TARAHUMARA TRUCKING - SITE DEVELOPMENT PLAN

TARAHUMARA TRUCKING COVER SHEET 2260 ANDES WAY AURORA, CO 80011

TARAHUMARA TRUCKING
JOB NO 954-1
CAD NO 954-1
DATE 03/30/23
SITE PLAN 2260 ANDES WAY
AURORA, CO 80011

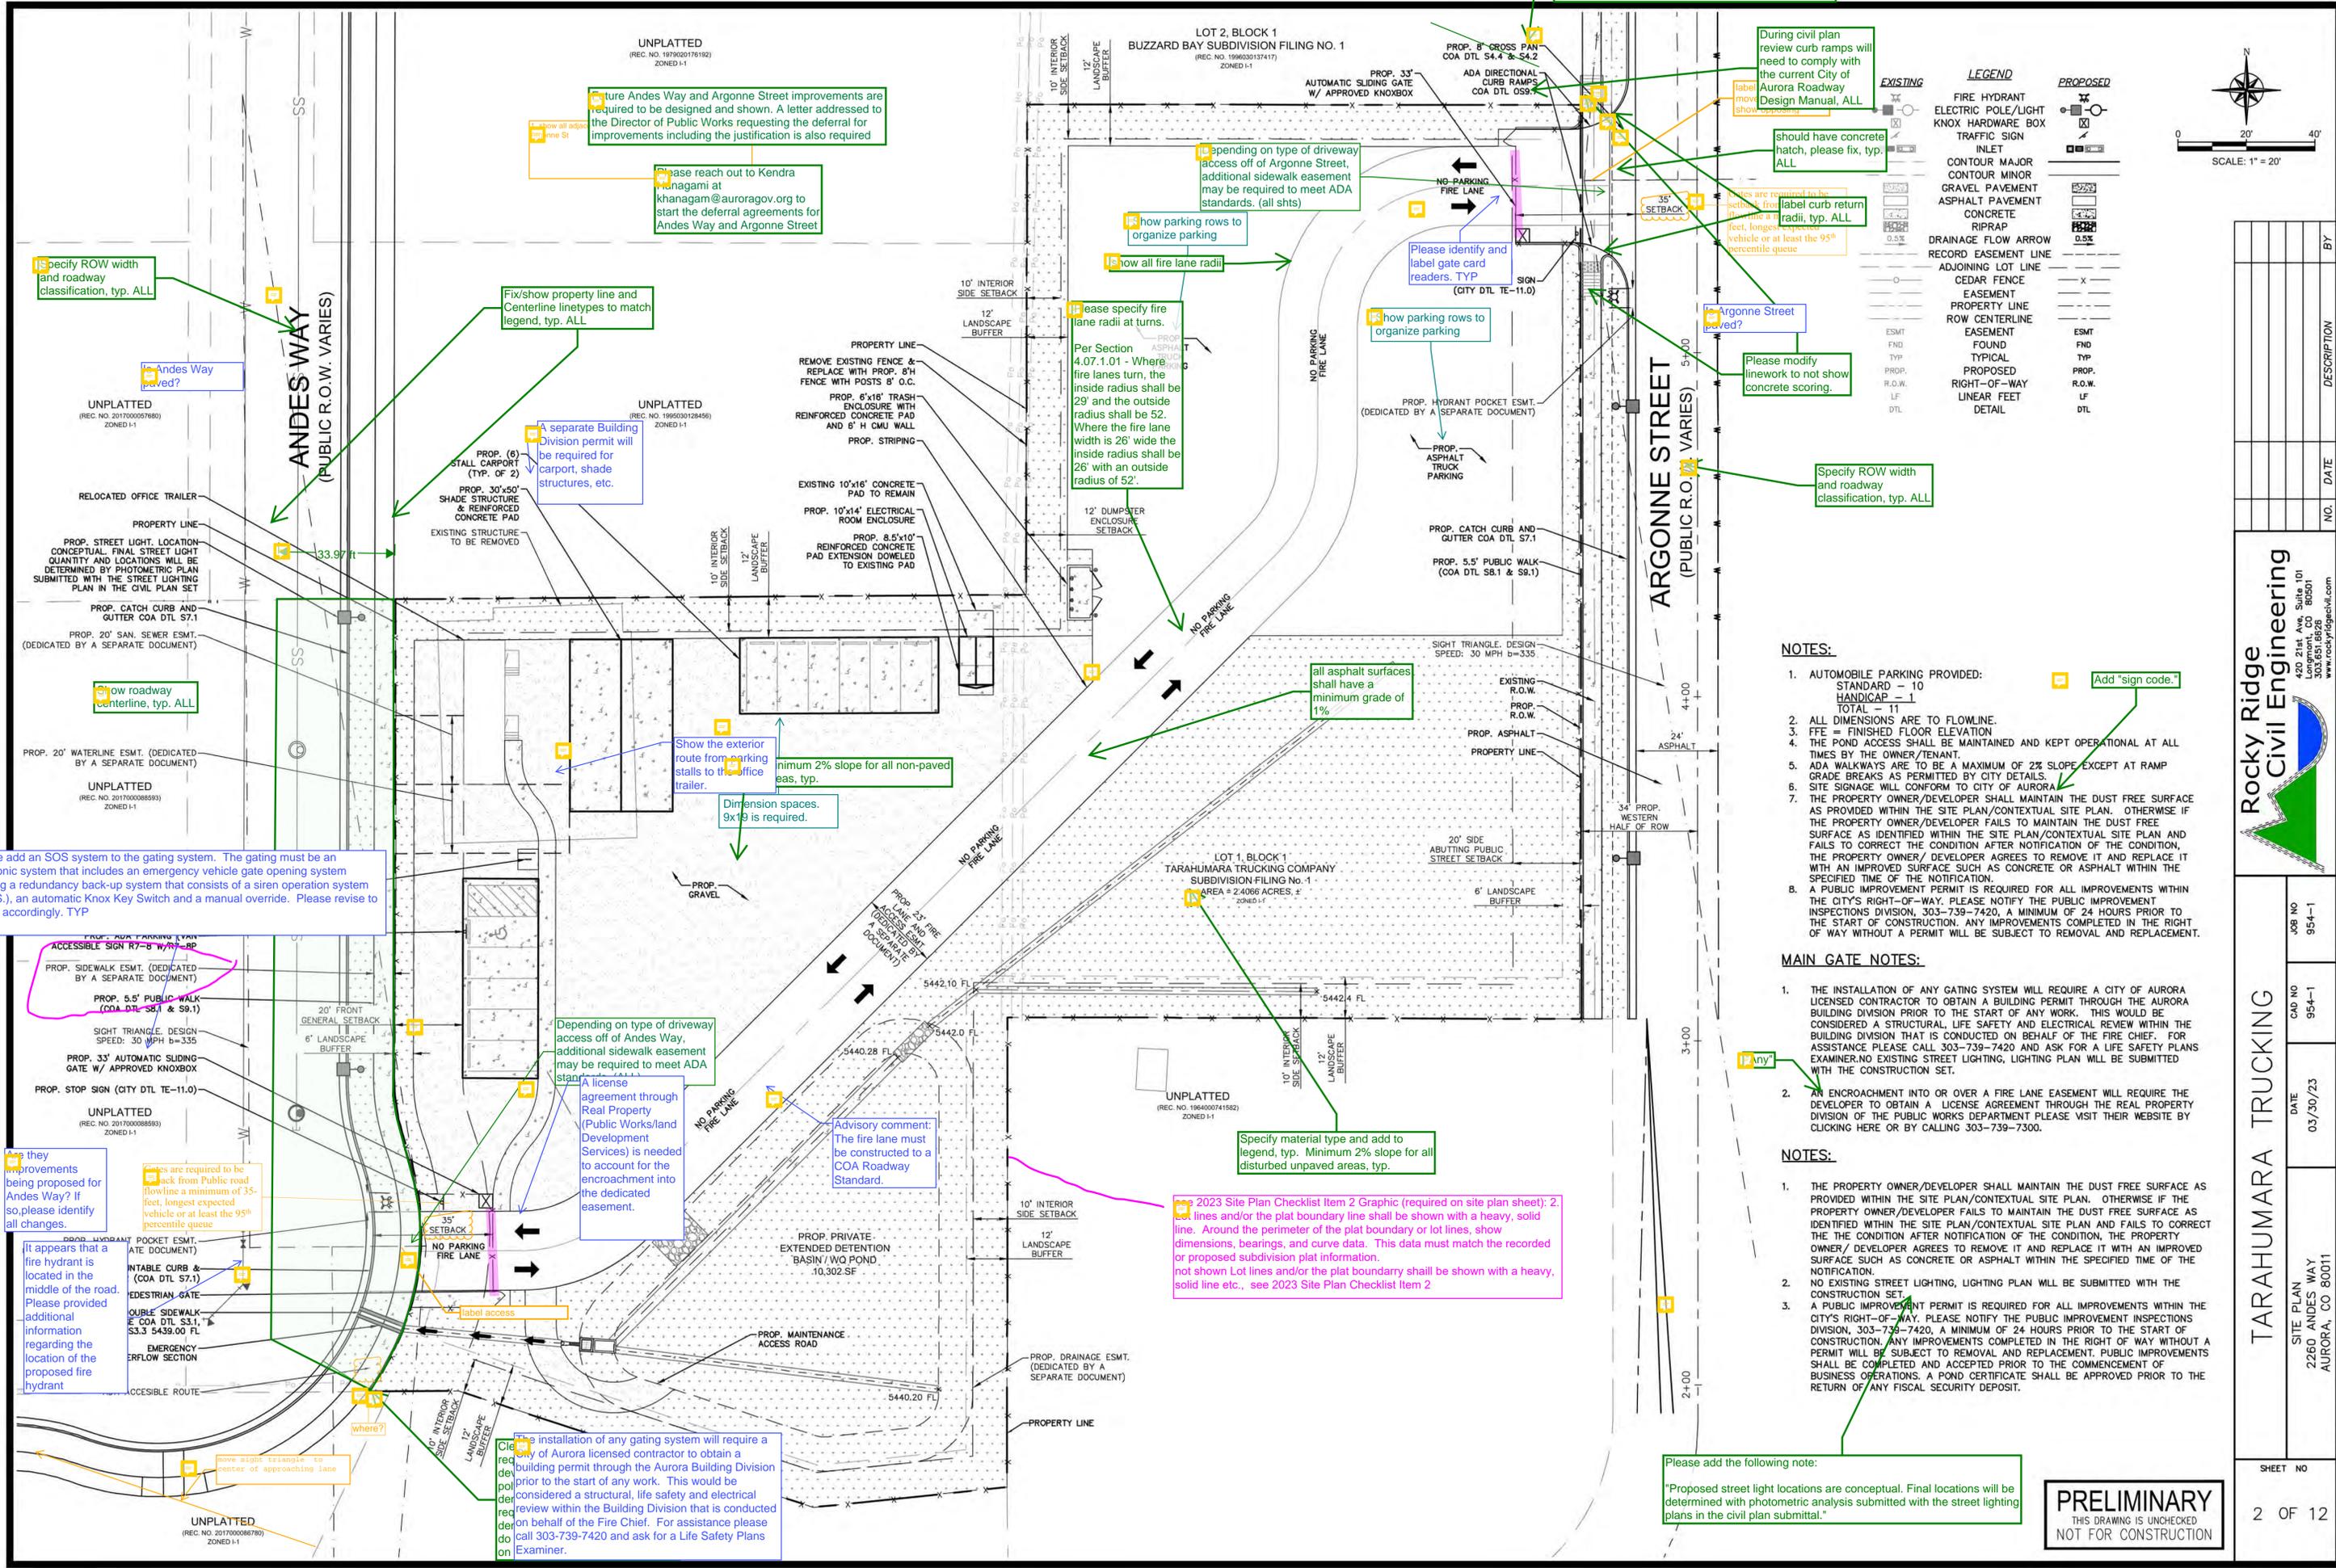
Staff recommends submission of elevations for curbs and carport, including building materials and colors

Add "Required accessible means of egress shall be continuous from each required accessible occupied area to the public way. The "Accessible Exterior Routes" shall comply with U.B.C. Chapter 11, Appendix 11, and C.A.B.O./A.N.S.I. 117.1."

Add subdivision Name: Tarahumara Subdivision Filing No. 1, typ. ALL

Add: The undersigned, their successors and assigns, hereby agree to indemnify the City of Aurora for any loss, damage or repair to city facilities that may result from the installation, operation or maintenance of said private irrigation lines or systems and/or private utilities.

Please revise code edition to the 2021

Replace with "Sections 126-271 and 126-278"

Replace note: The developer is responsible for signing and striping all public streets. The developer is required to place traffic control, street name, and guide signs on all public streets and private streets approaching an intersection with a public street. Signs shall be furnished and installed per the most current editions of The Manual on Uniform Traffic Control Devices (MUTCD) and the City Standards, and shown on the signing and striping plan for development.

Add: "Signs shall be furnished and installed per the most current editions of the manual on uniform traffic control devices (MUTCD) and city standards, shown on the signing and striping plan for development."

Add note: BENCHMARK CITY OF AURORA BM JS8633NE002 - COA BRASS CAP SET IN NOSE OF MEDIAN IN TOWER. The streetlight or pedestrian light installation within the public right-of-way shall be designed, funded, and constructed by the developer/owner. Ownership and maintenance of the street/pedestrian lights shall be the responsibility of the City of Aurora once they have been accepted. Street light and/or pedestrian photometrics plans shall be prepared and submitted to the City for review and approval and shall become a part of the approved civil construction plans for the project. An electrical plan showing site location of lights, electrical one line and grounding details shall be submitting to the Permit Center for review by the Building Department. The owner is responsible for obtaining an address for the meter(s) from the Planning Department. A Building Permit for the meter and a Public Inspections Permit for the street lights are required. Certificate of occupancies will not be issued until the street and/or pedestrian lighting plans are approved, constructed, and initially accepted.

For every six of fraction of six accessible parking spaces, at least one shall be a van-accessible parking space. Please revise to reflect a van accessible parking stall.

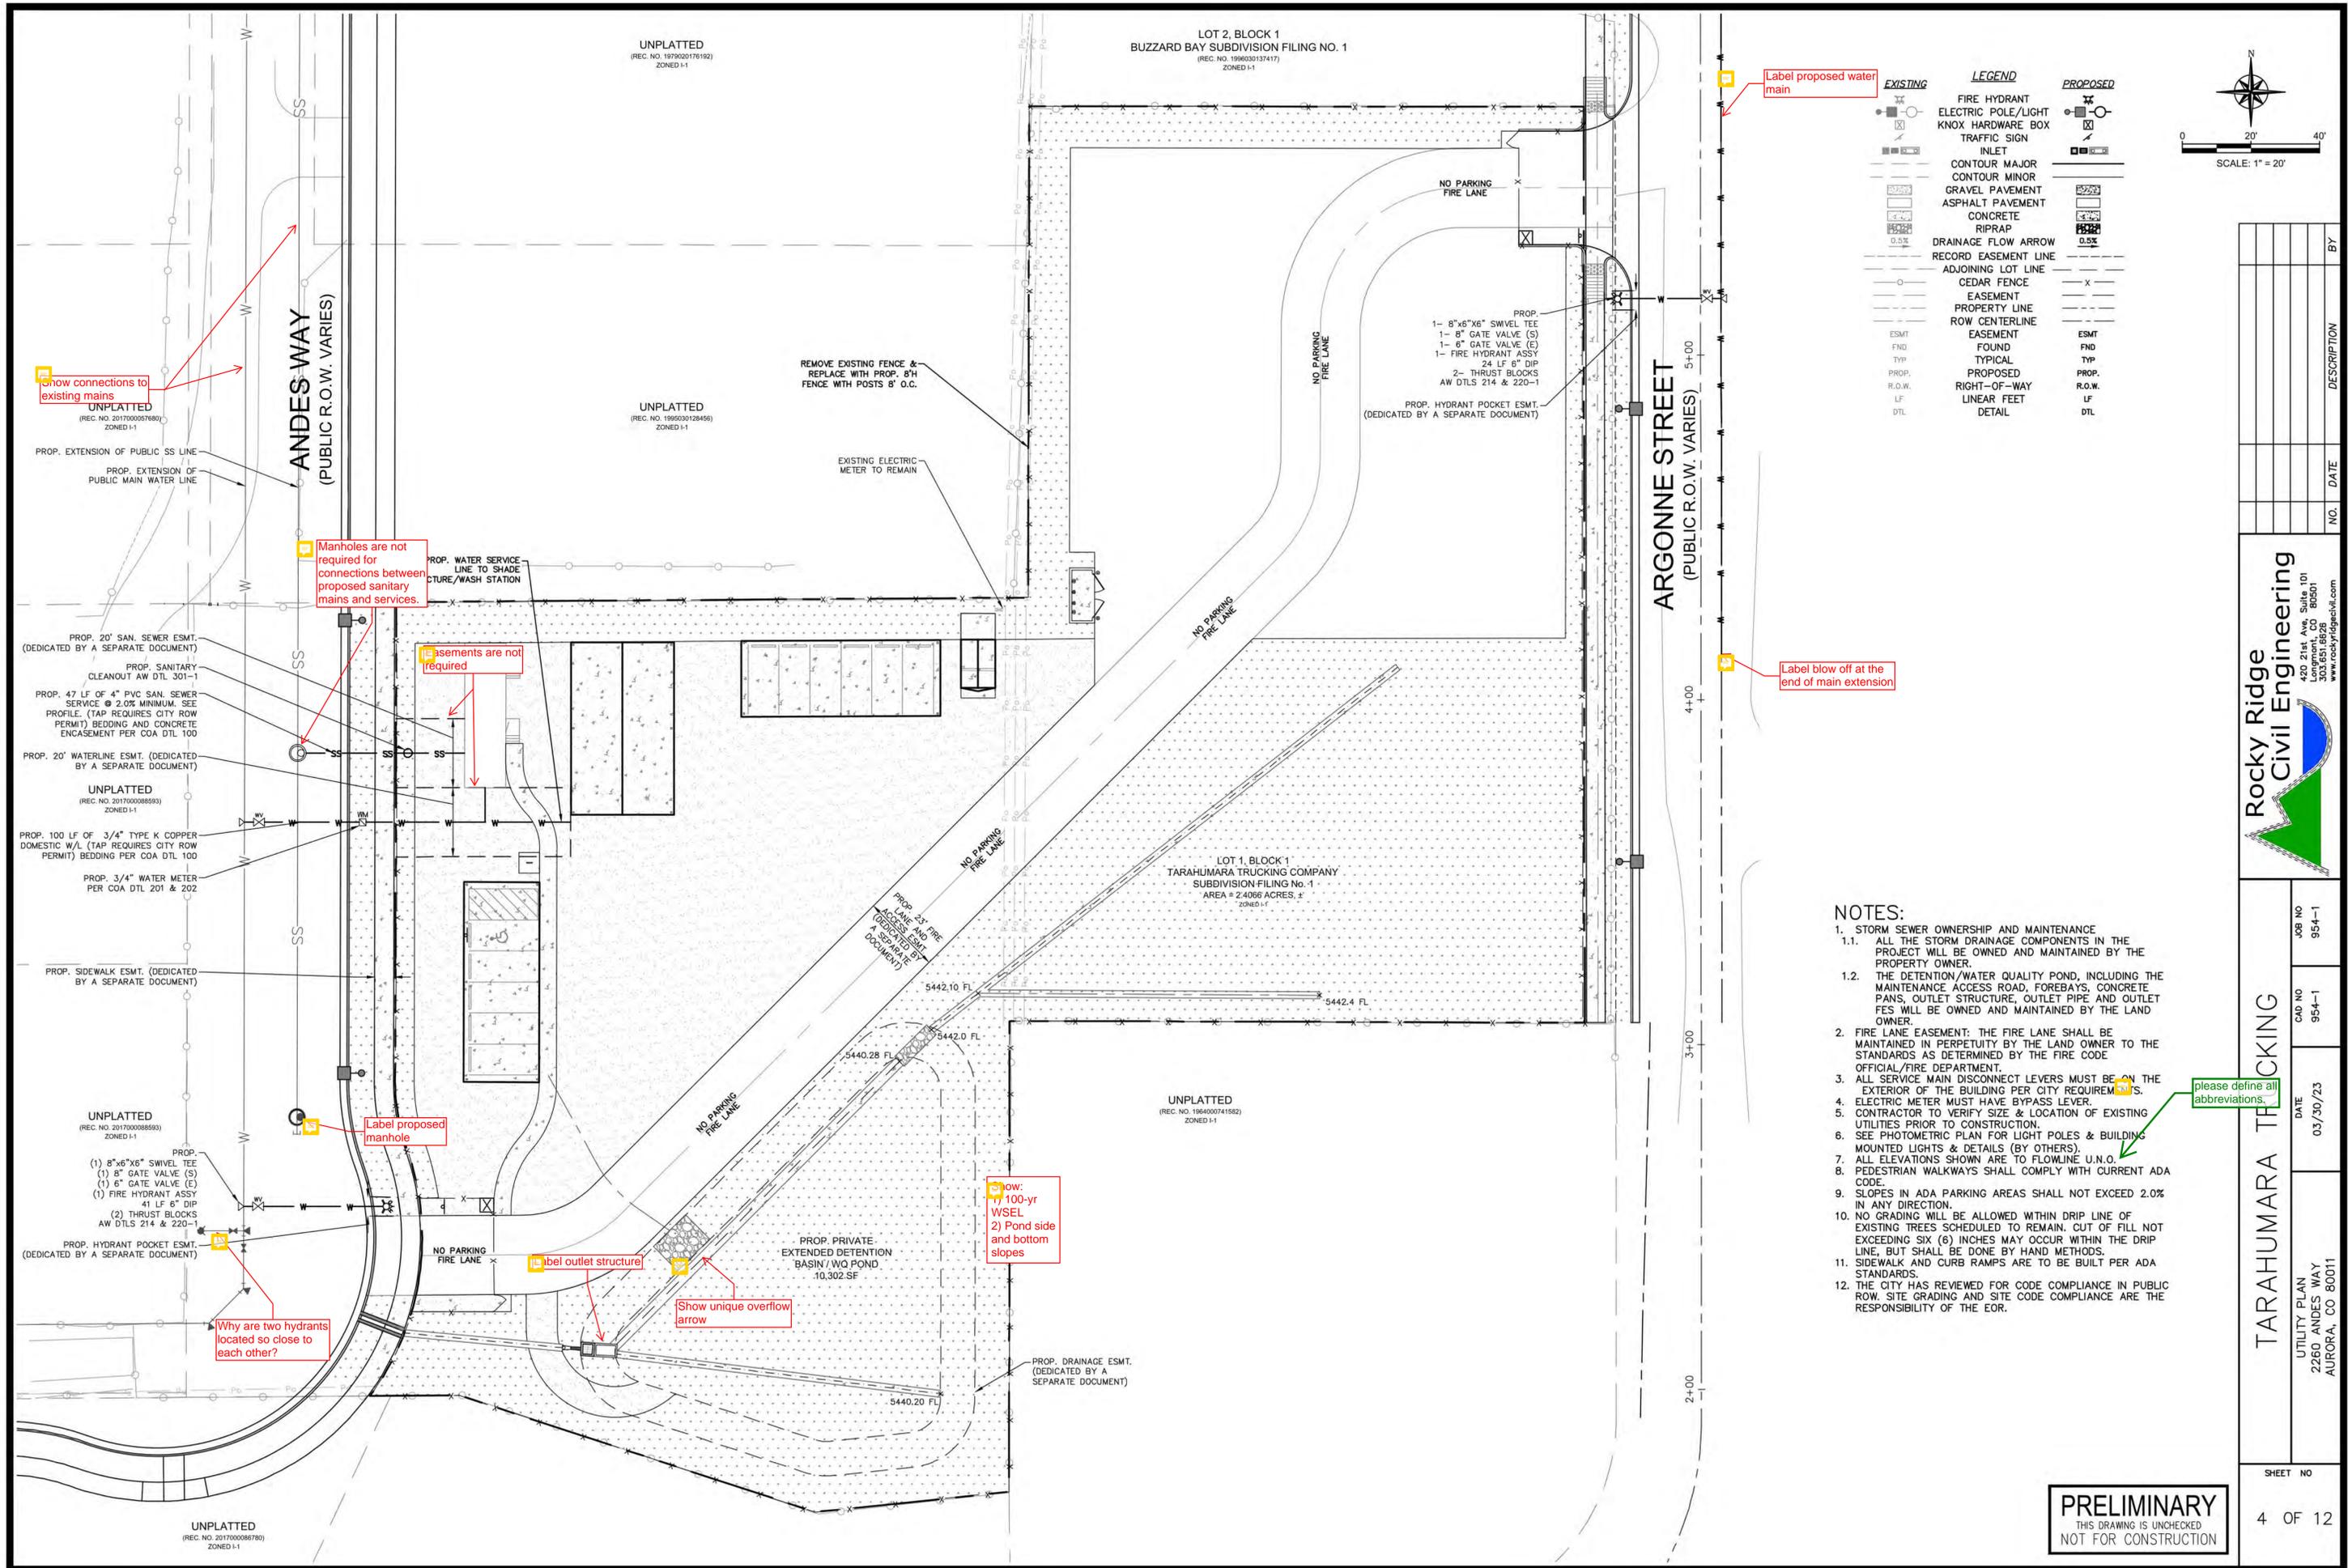
During civil plan review curb ramps will need to comply with the current City of Aurora Roadway Design Manual, ALL

should have concrete hatch, please fix, typ. ALL

Notes are required to be shown from label curb return dimension at radii, typ. ALL

Argonne Street moved?

Please modify linework to not show concrete scoring.

Specify ROW width and roadway classification, typ. ALL

Please add the following note:
"Proposed street light locations are conceptual. Final locations will be determined with photometric analysis submitted with the street lighting plans in the civil plan submittal."
